**Subject:** Response to DMS Comments for DRAFT Monitoring Year 5 Report  
Thomas Creek Restoration Project, Wake County  
DMS Project # 96074, DEQ Contract #5549, RFP# 16-005020

# **Thomas Creek Restoration Project Year 5 Monitoring Report - FINAL**

DMS Project ID Number – 96074, DEQ Contract No. 5549

# Figure 7. Pebble Count Plot Data

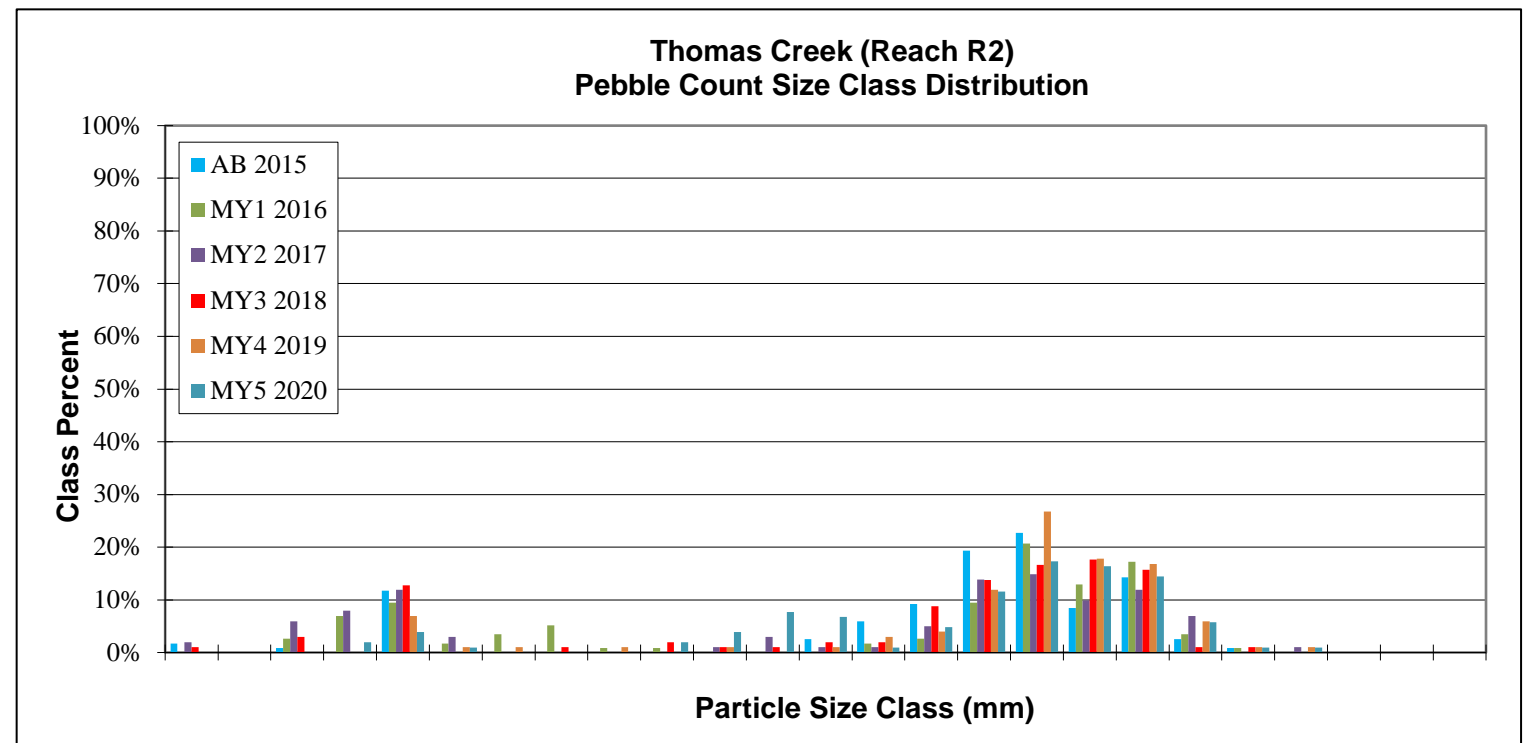
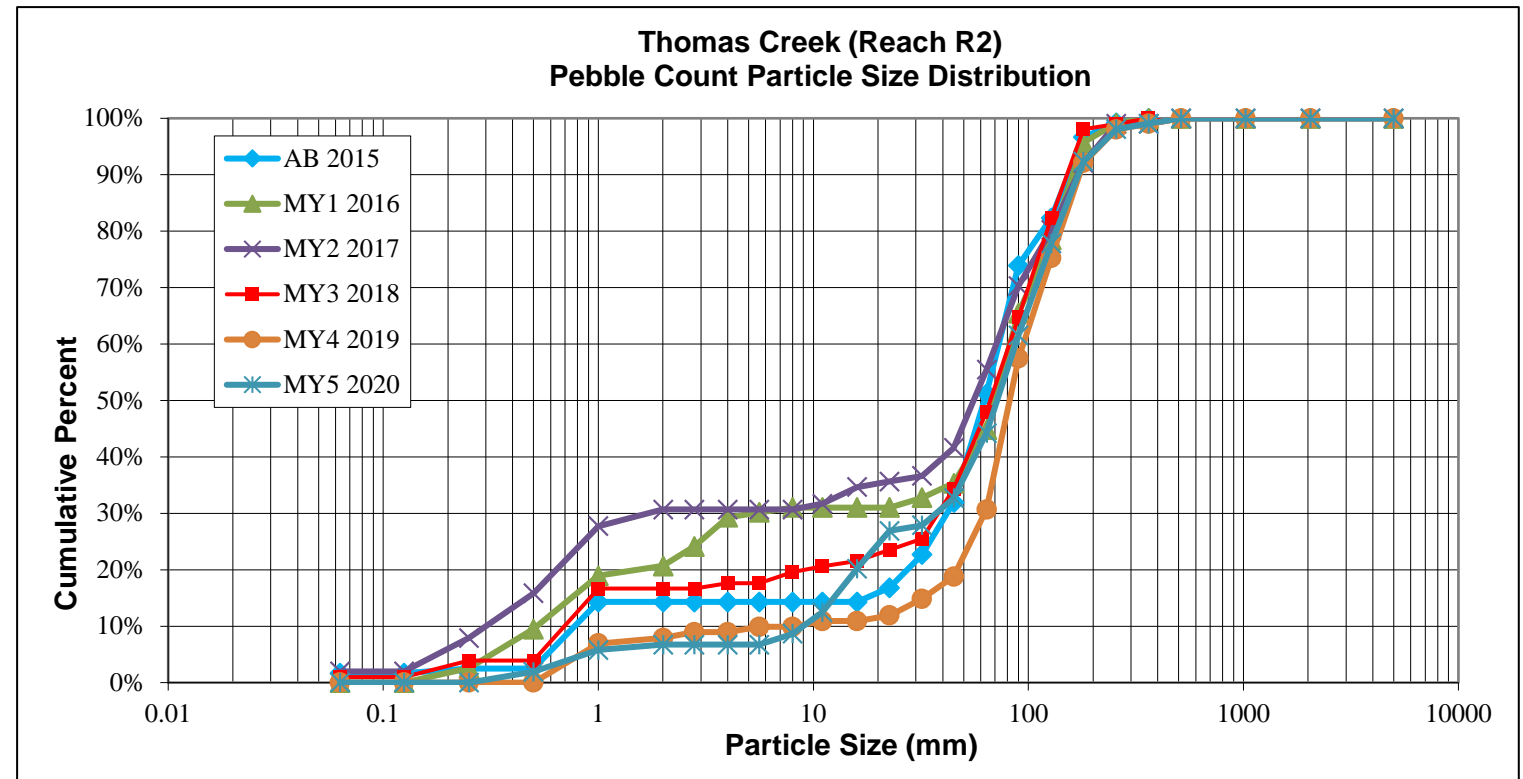
- b. Please submit photos as jpegs rather than a pdf.  
**Response: Photos have been provided as individual JPGs in the revised digital documents.**
  - c. Please submit pebble count data used to create figures.

**Response: The figures include the pebble count by size data used to generate the two graphs, but scanned copies of the original field collection forms have also been included with the revised digital files.**

**Figure 8. Flow Gauge Graphs**

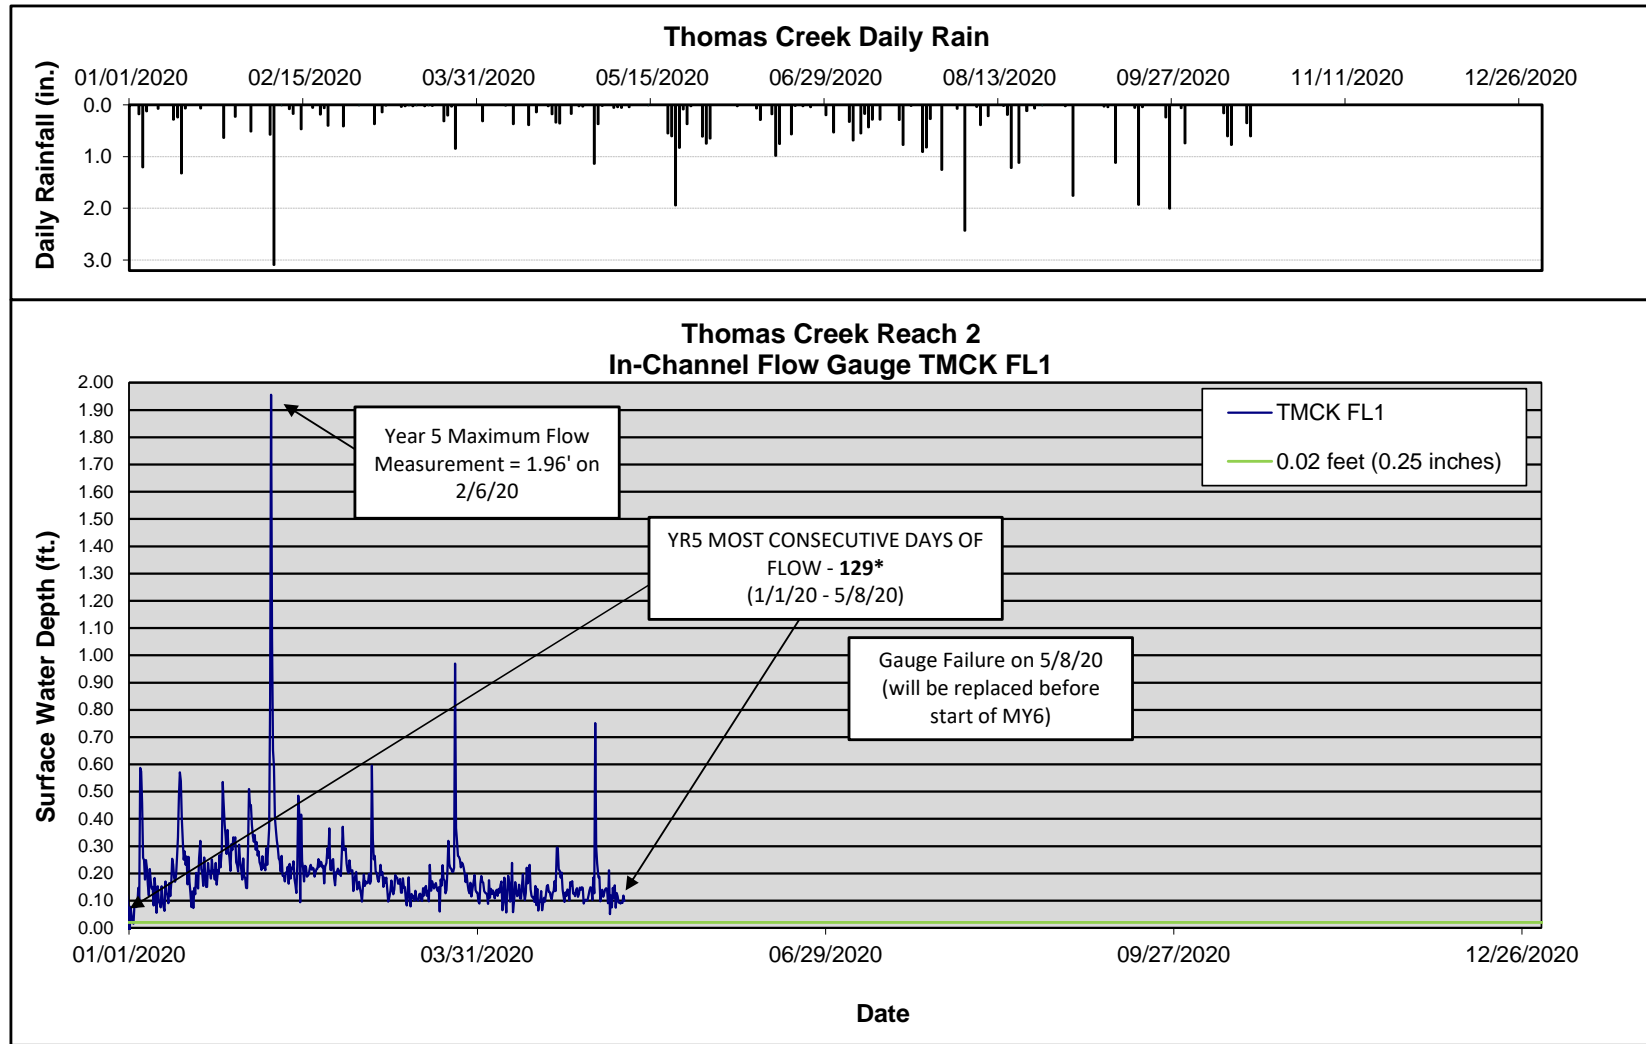
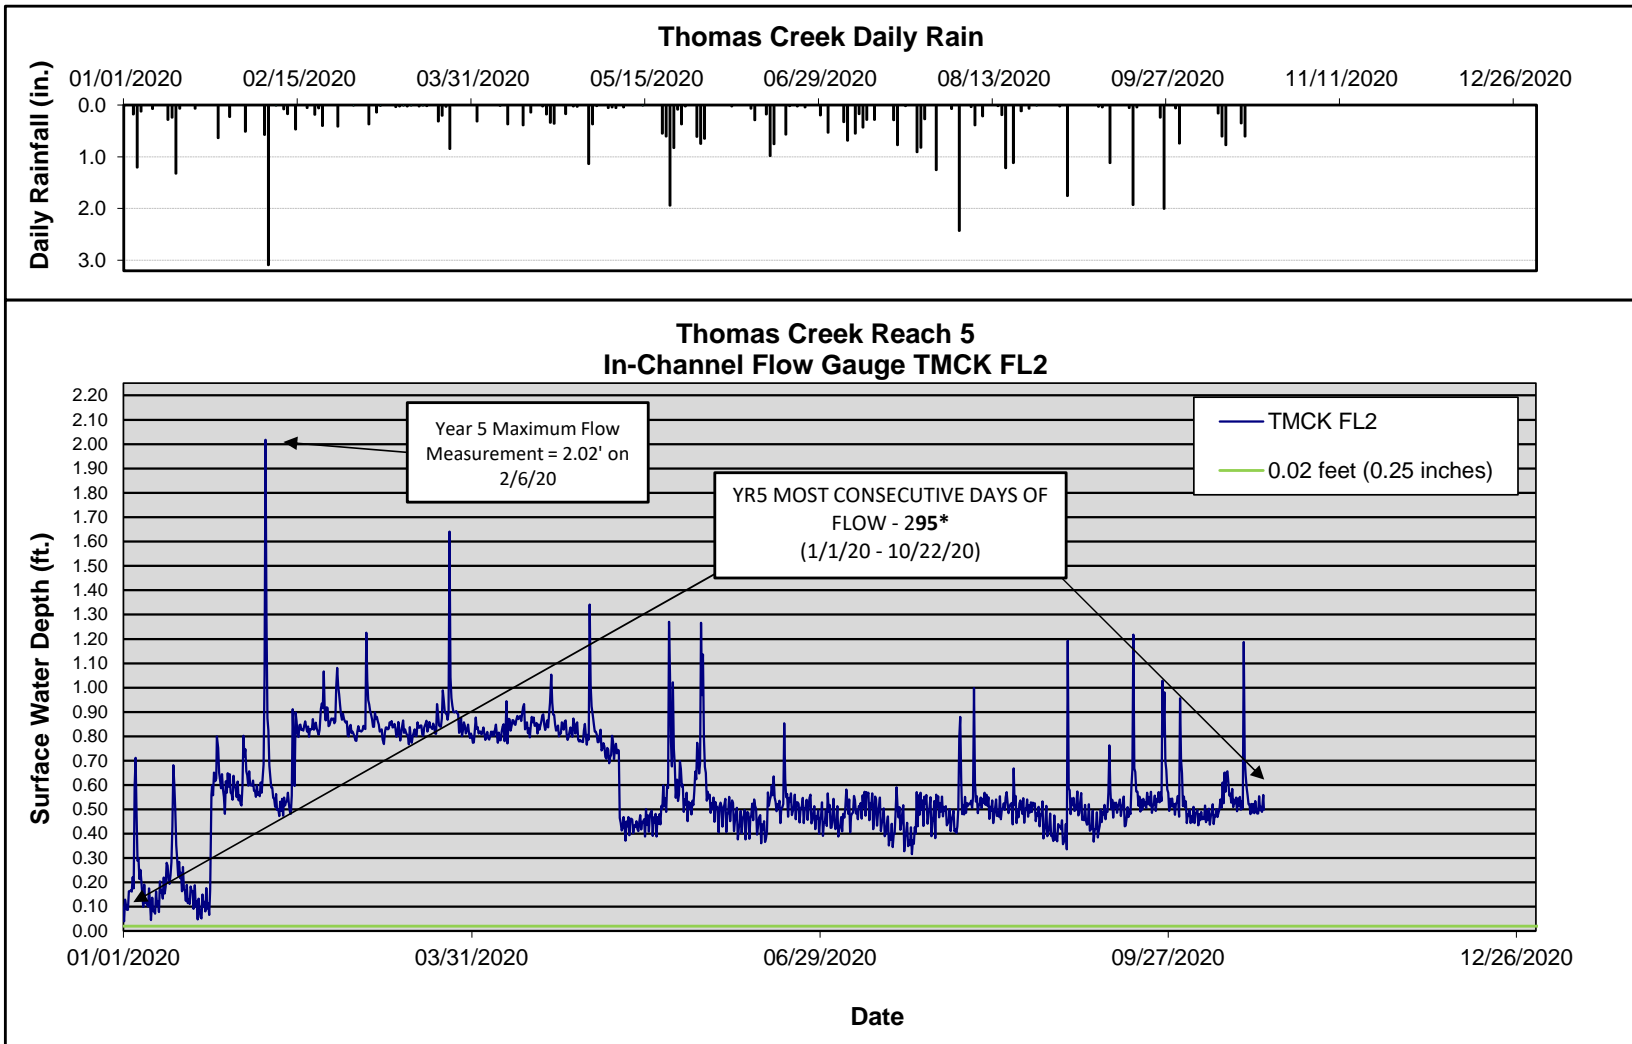
- d. Please submit the data used to create the flow gauge figures.  
**Response: The flow gauge data used to create the figures has been provided with the revised digital files.**
